Access Compliance Report

Public Rights-of-Way (Curb Ramps)

Intersection ID: 50325	Main Street: FITCHBURG_CT	Cross Street: SHARPES_CR	Location: SE
ADA ID: CE802F77D855	Ramp Type: PerpDiag	Initial Pass/Fail: Fail	Overall Compliance: No
		Severity Score: 8.75

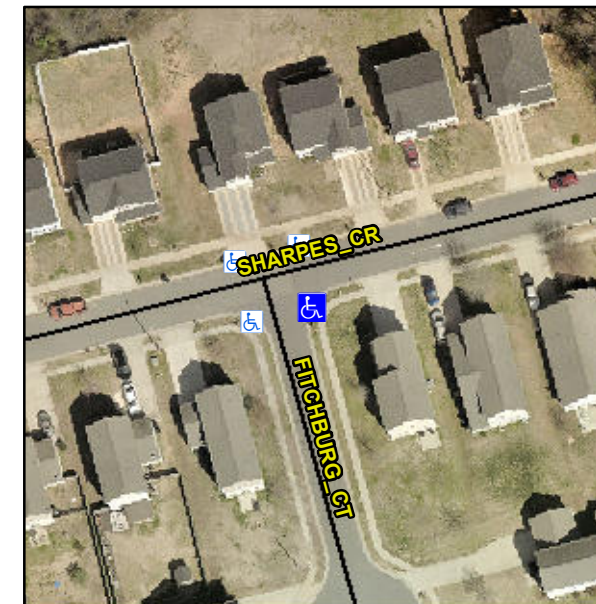
Not Found, R304.5.1

Compliance	Description	Data	Compliance	Description	Data
N/A	Ramp Length (in)	49.0	Yes	Ramp Slope (%)	5.5
No	Ramp Width (in)	47.5	Yes	Ramp XSlope (%)	1.0
N/A	Flare Type LT	N/A	N/A	Flare Type RT	N/A
N/A	Flare Slope LT (%)	N/A	N/A	Flare Slope RT (%)	N/A
N/A	Flare Traversable LT?	N/A	N/A	Flare Traversable RT?	N/A
N/A	Landing Length (in)	N/A	N/A	DWS Provided?	N/A
N/A	Landing Width (in)	N/A	N/A	DWS Contrast?	N/A
N/A	Landing Slope (%)	N/A	N/A	DWS Length (in)	N/A
N/A	Landing X Slope (%)	N/A	N/A	DWS Full Width?	N/A
N/A	Landing Curb? (Y/N)	N/A	N/A	DWS Offset (in)	N/A
N/A	Shared Landing?	N/A			
N/A	Gutter Ponding?	Yes	N/A	Gutter Slope (%)	N/A
N/A	Gutter Lip Ht (in)	N/A	N/A	Gutter X Slope (%)	N/A
N/A	Painted X Walk1?	No	N/A	Painted X Walk2?	No
	X Walk 1 Direction	To N		X Walk 2 Direction	To W
N/A	X Walk 1 Width (in)	N/A	N/A	X Walk 2 Width (in)	N/A
	X Walk 1 Slope (%)	3.1		X Walk 2 Slope (%)	6.0
	X Walk 1 X Slope (%)	3.3		X Walk 2 X Slope (%)	3.8

Remove & Replace Curb Ramp With Two New Directional Ramps or Equivalent.
